TOWN OF MILTON
PLANNING AND DEVELOPMENT
JUNIPER 12F MODEL

BUILDING: REVIEWED
SCOTT SHERRIFFS APR 13, 2017
PLANS EXAMINER DATE

JUNIPER 12
ENERGY STAR

PROJECT NAME
LECCO RIDGE

BASEMENT FLOOR PLAN '2'

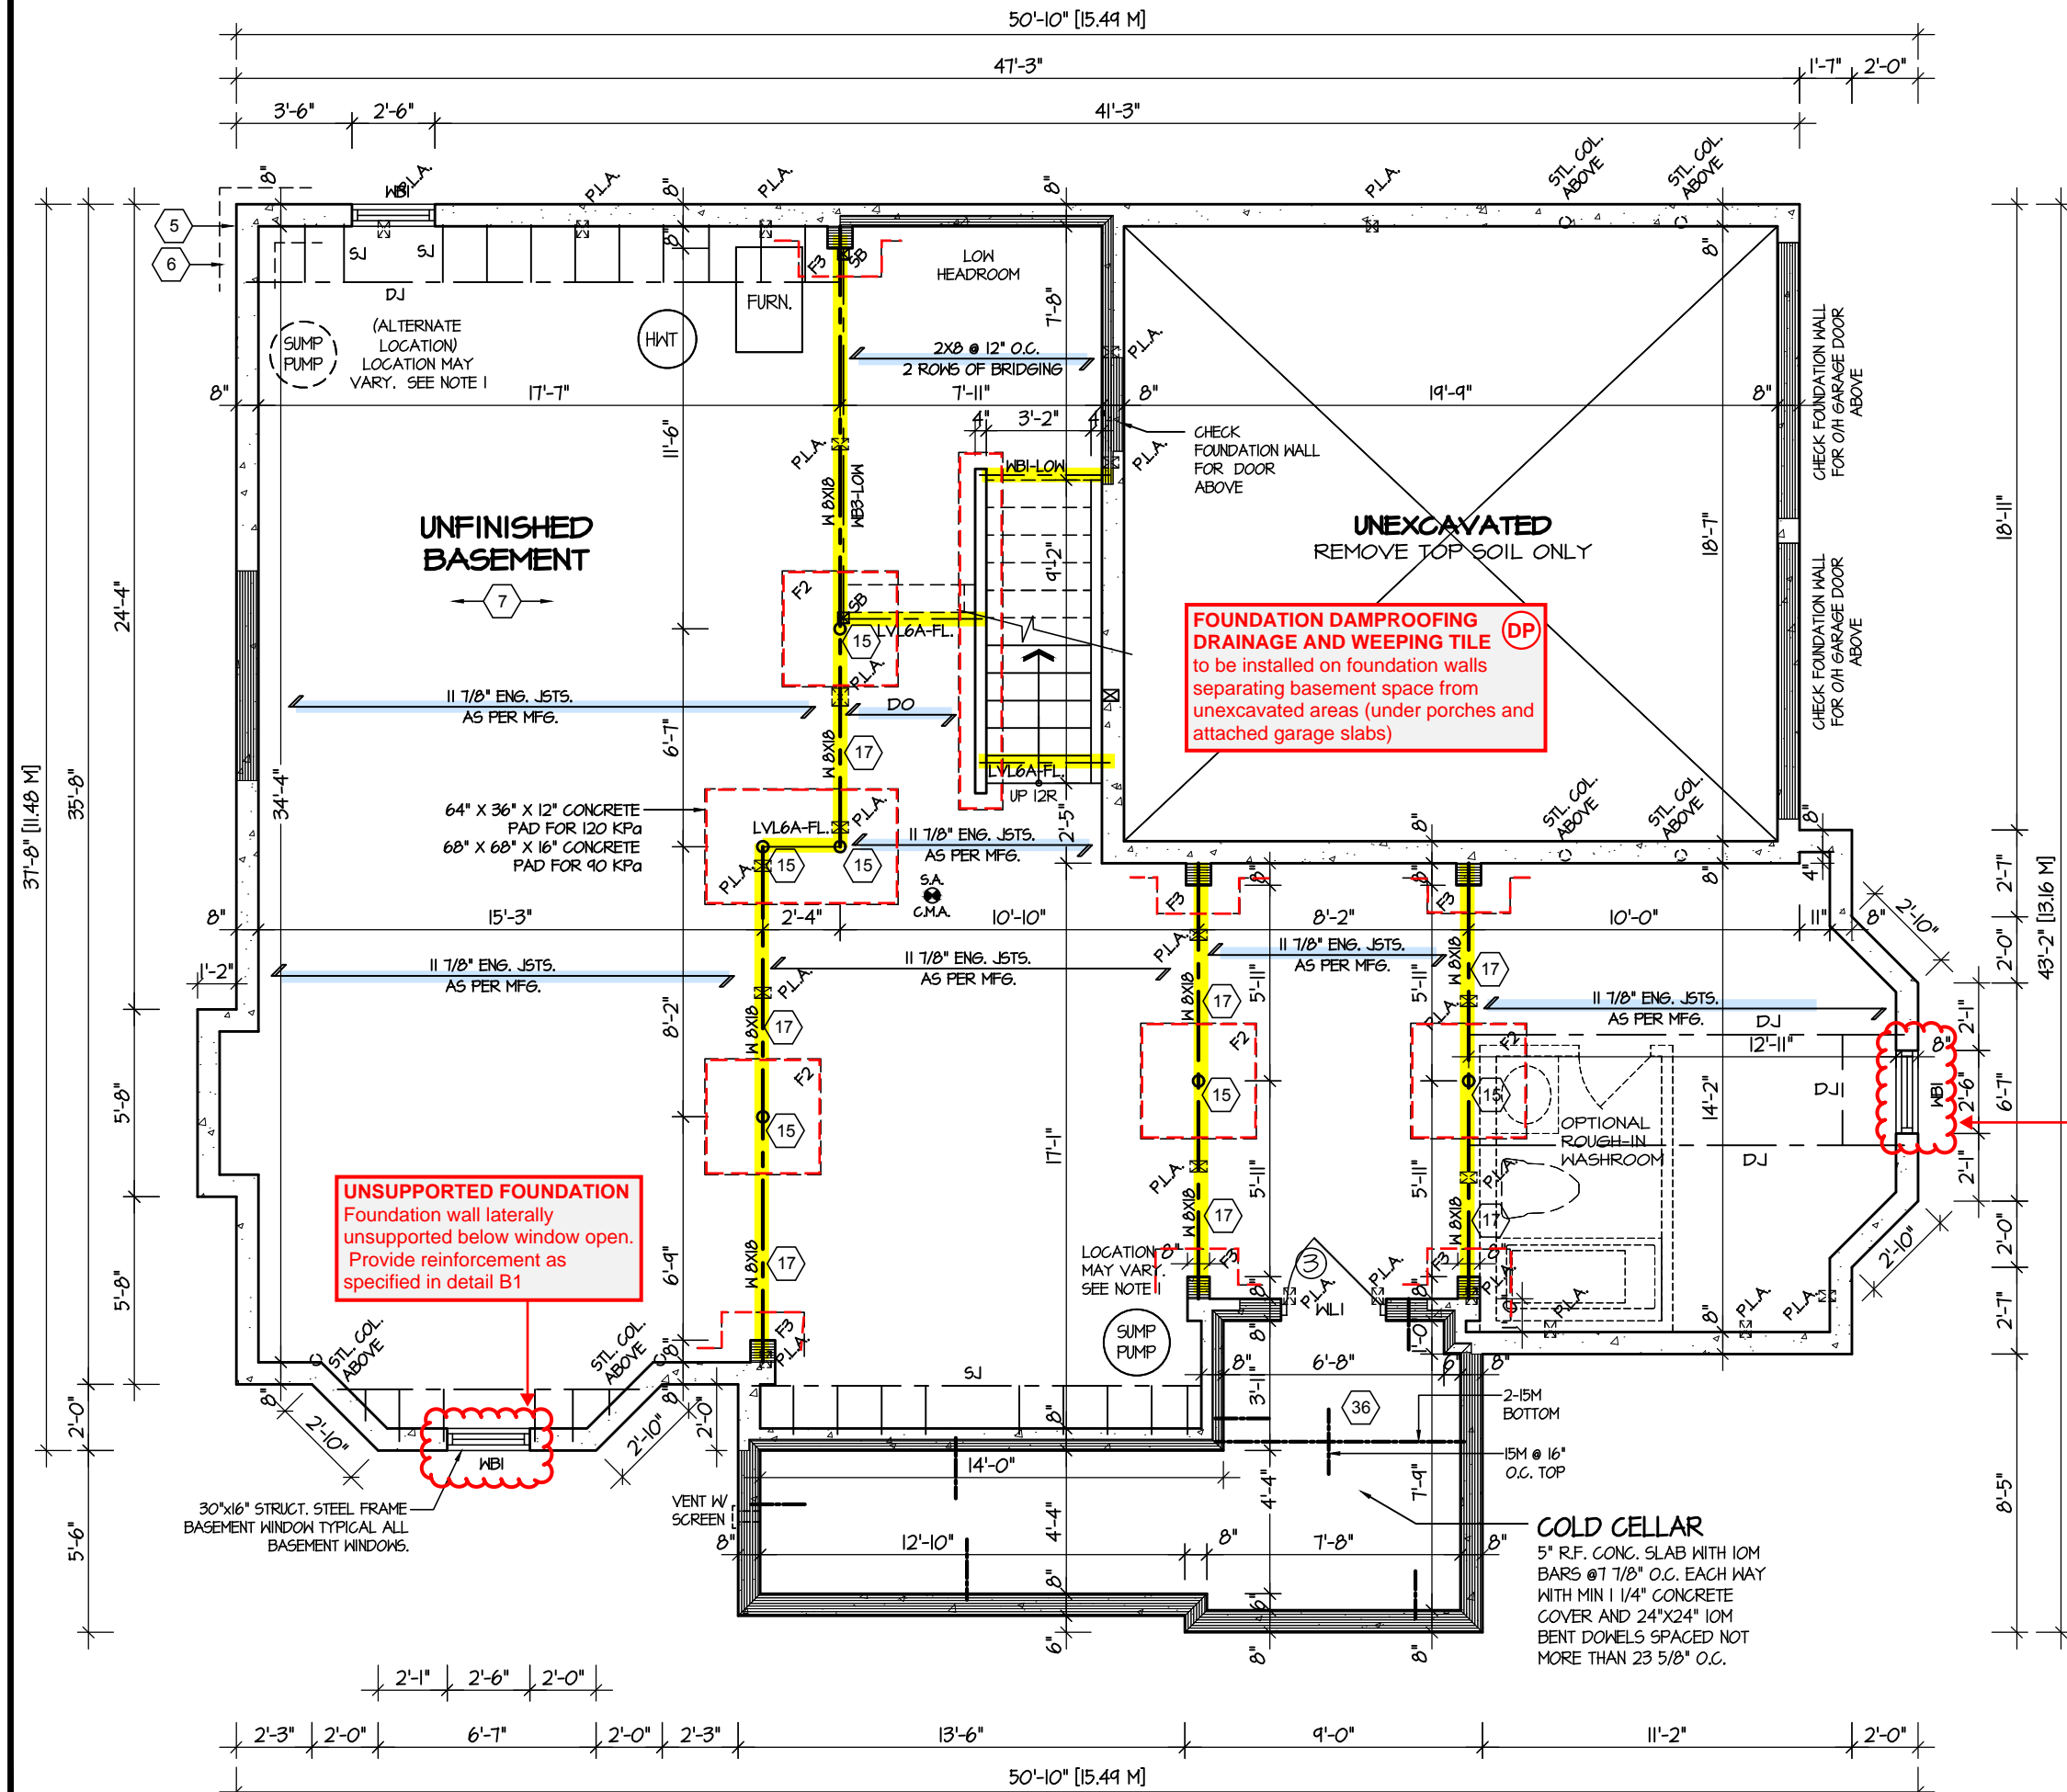
UNSUPPORTED FOUNDATION
Foundation wall laterally unsupported below window open. Provide reinforcement as specified in detail B1

UNSUPPORTED FOUNDATION
Foundation wall laterally unsupported below window open. Provide reinforcement as specified in detail B1

FIRST FLOOR PLAN 'I'

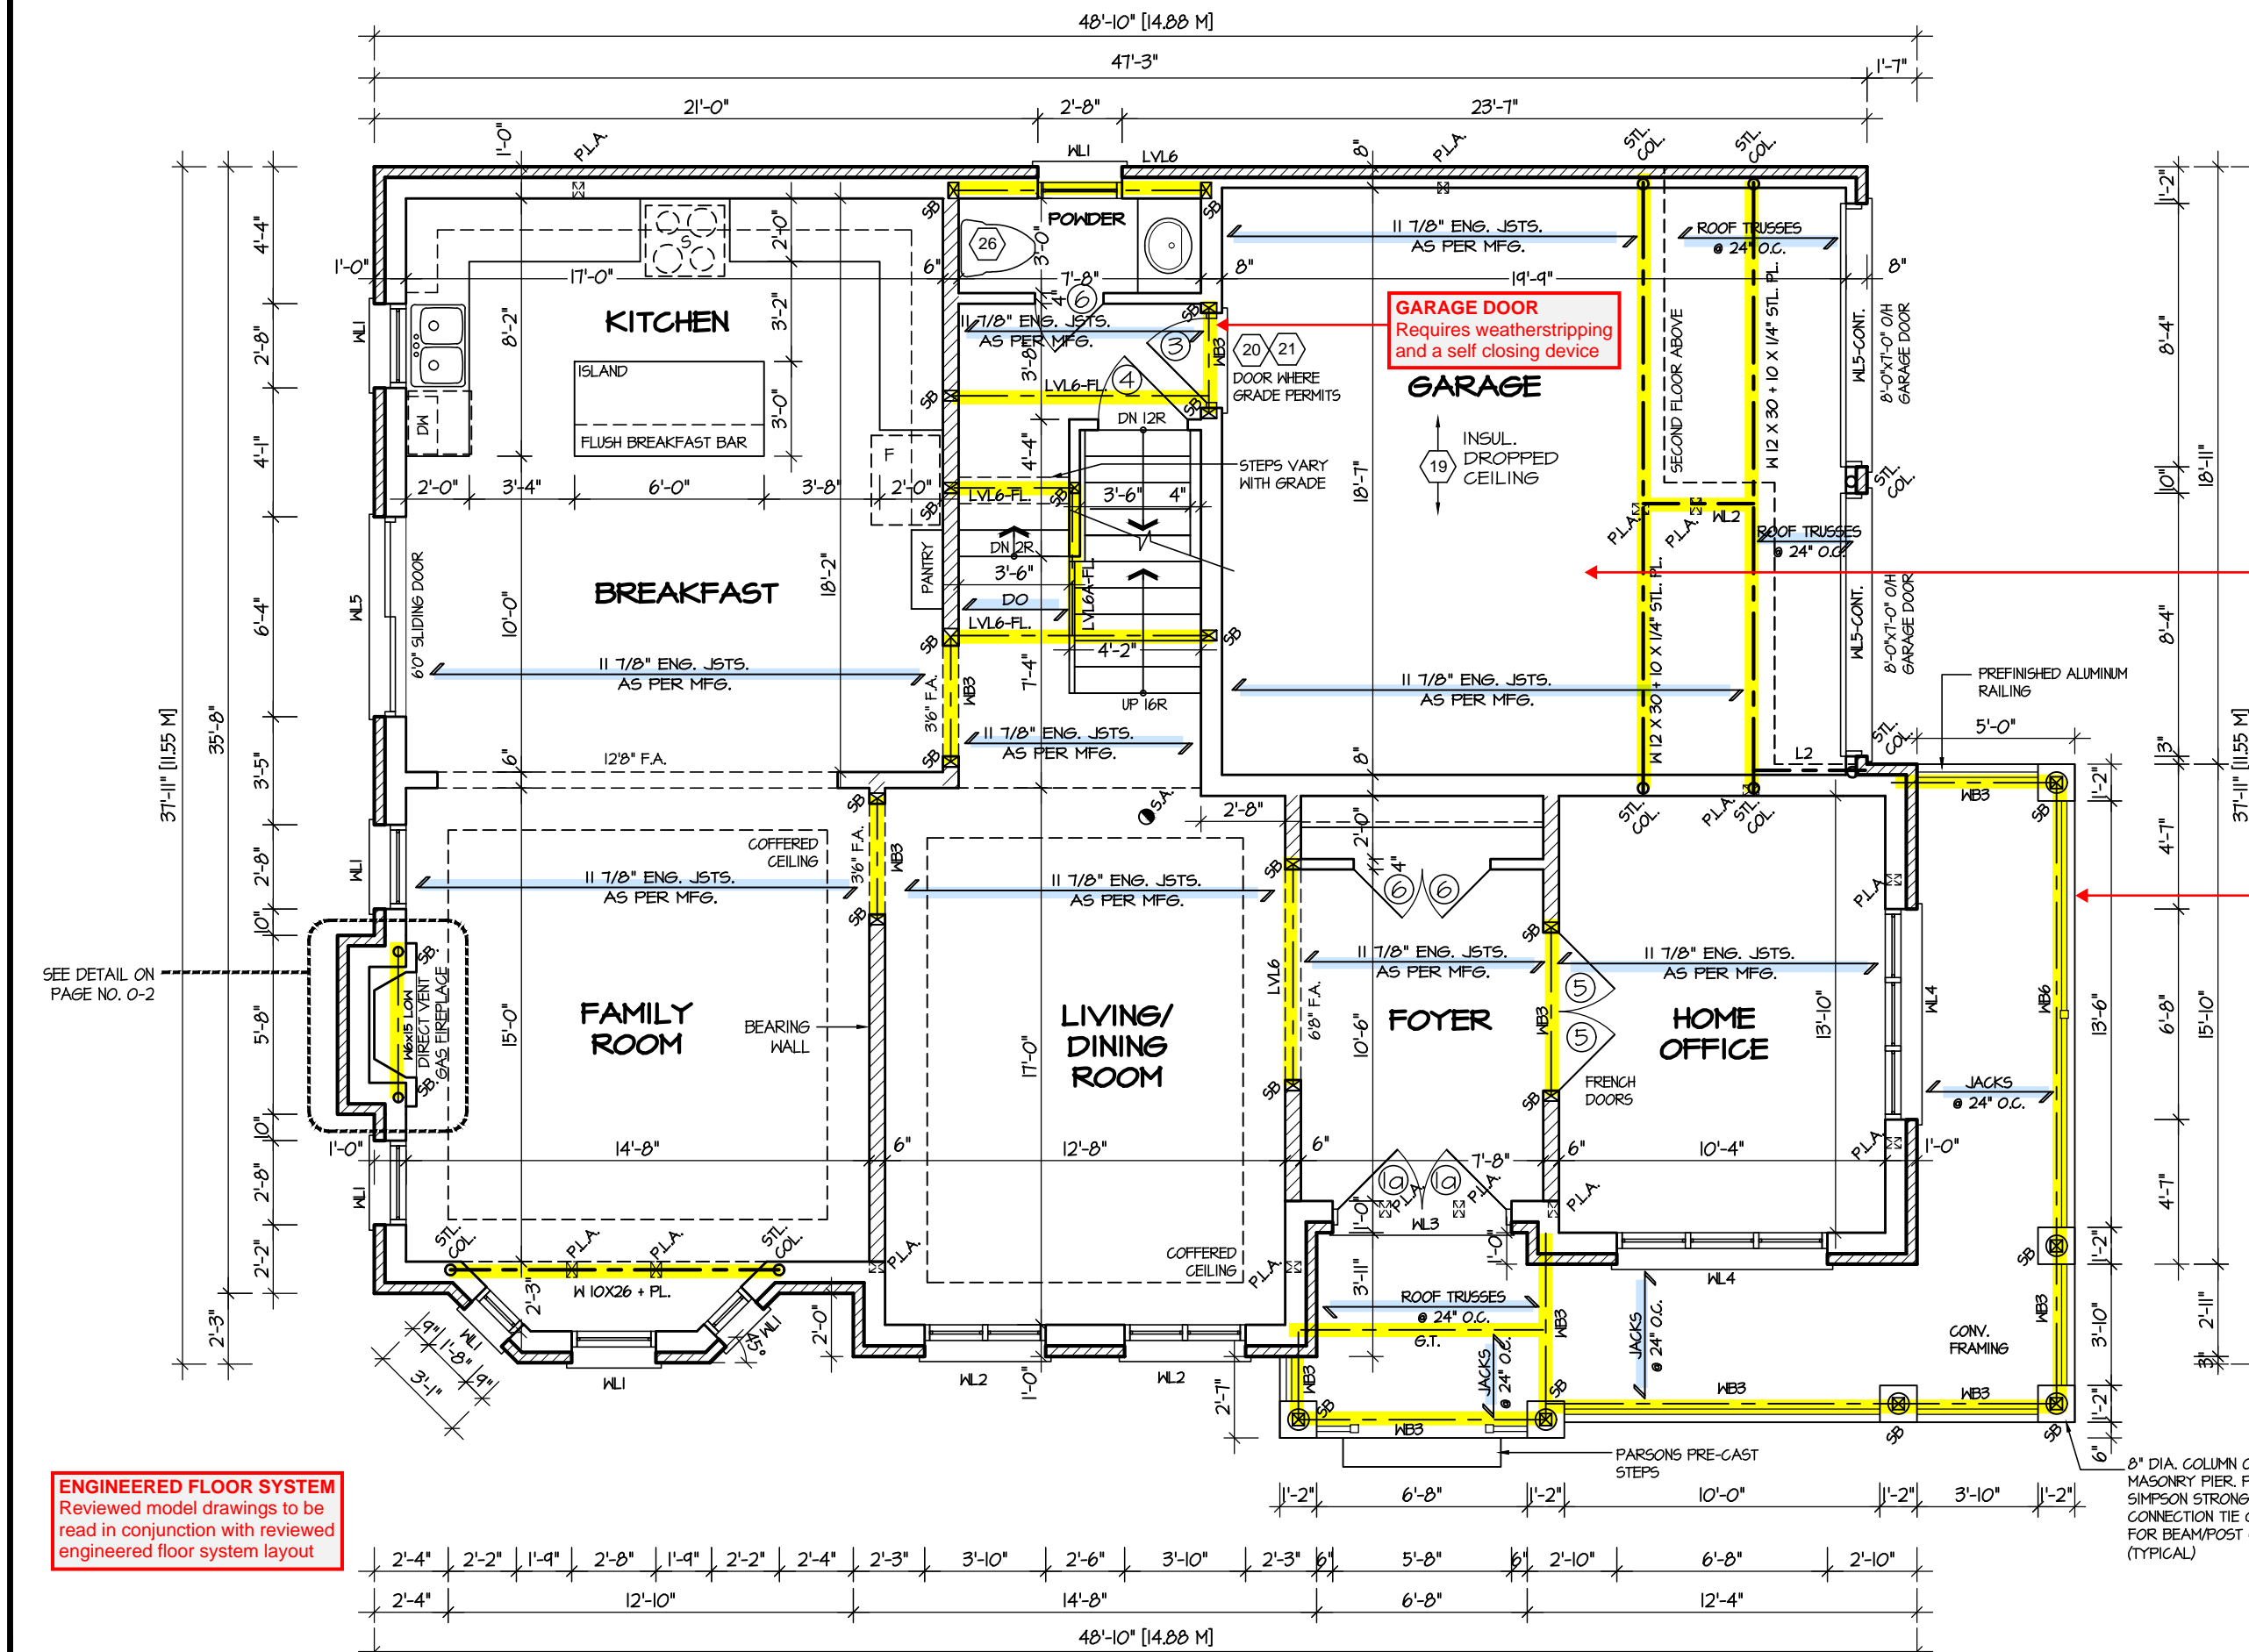
GARAGE AIR BARRIER
Garage walls/ceiling required to include an air barrier system. Membrane materials shall have joints sealed and structurally supported

GUARDS/HANDRAILS
Shall be provided on porches as required based on final lot grading

FIRST FLOOR PLAN '2'

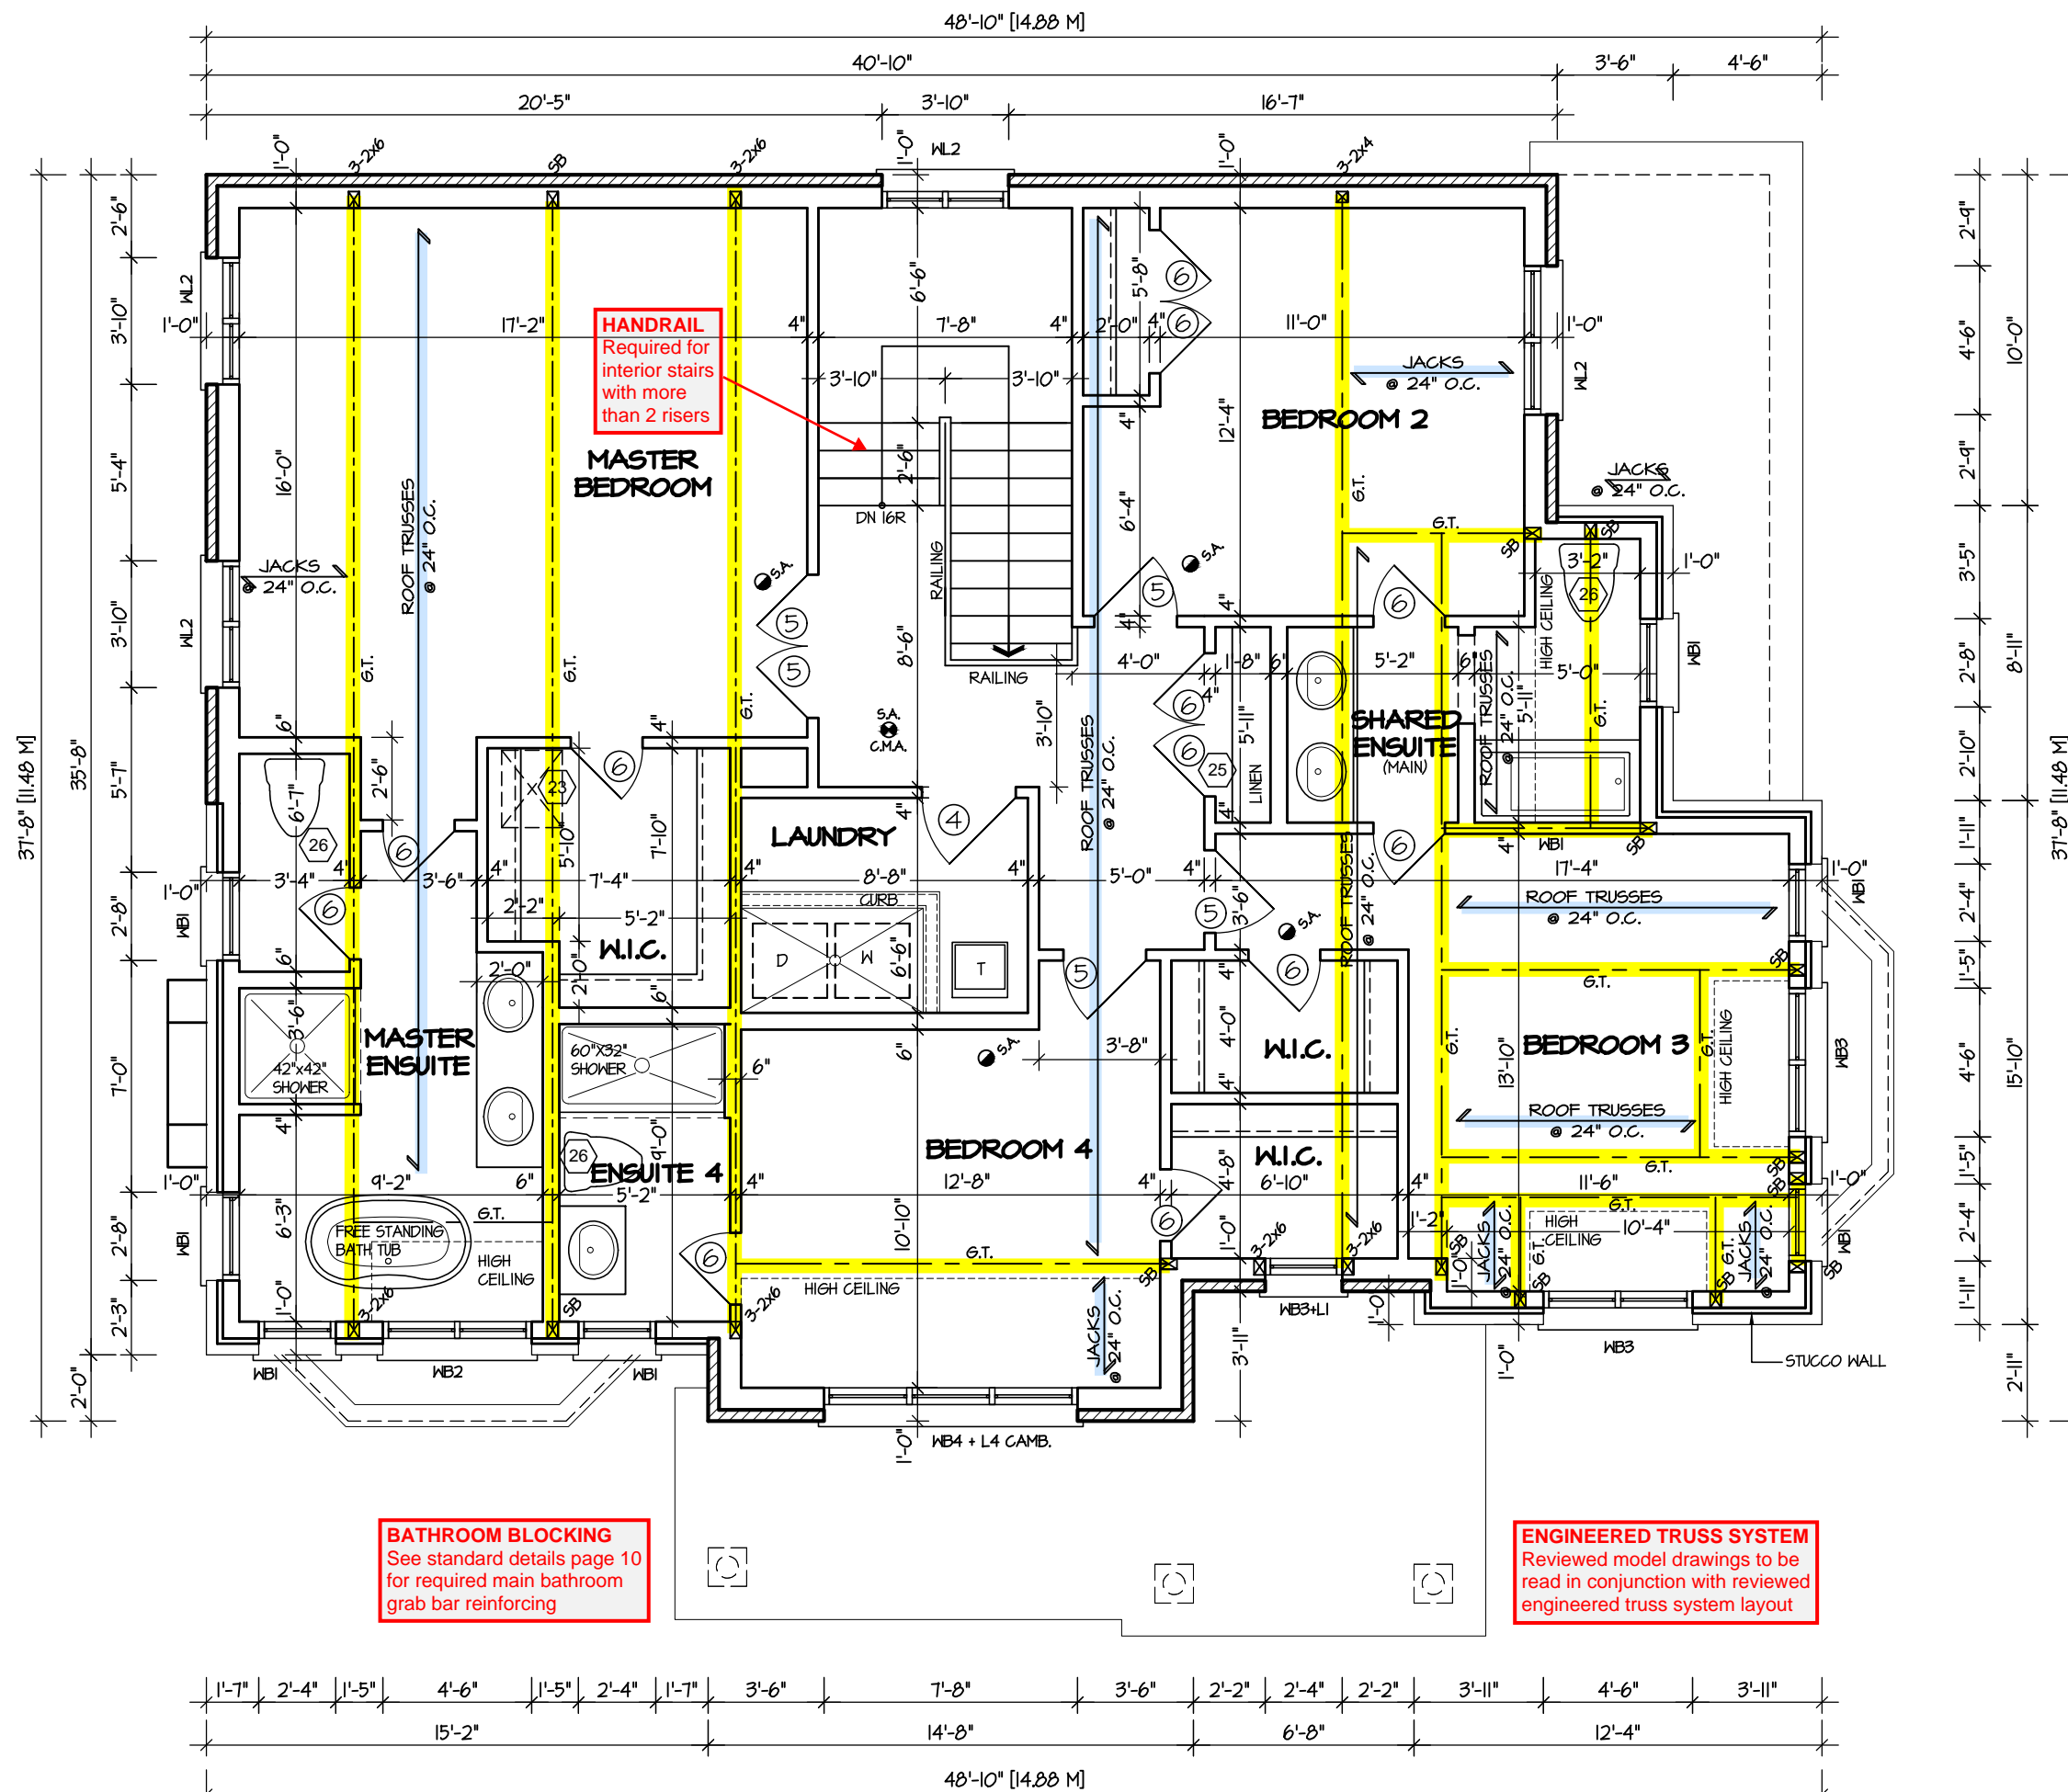
GARAGE AIR BARRIER
Garage walls/ceiling required to include an air barrier system. Gypsum board used as an air barrier requires all joints to be sealed with tape and a minimum 1 coat of compound

GUARDS/HANDRAILS
Shall be provided on porches as required based on final lot grading
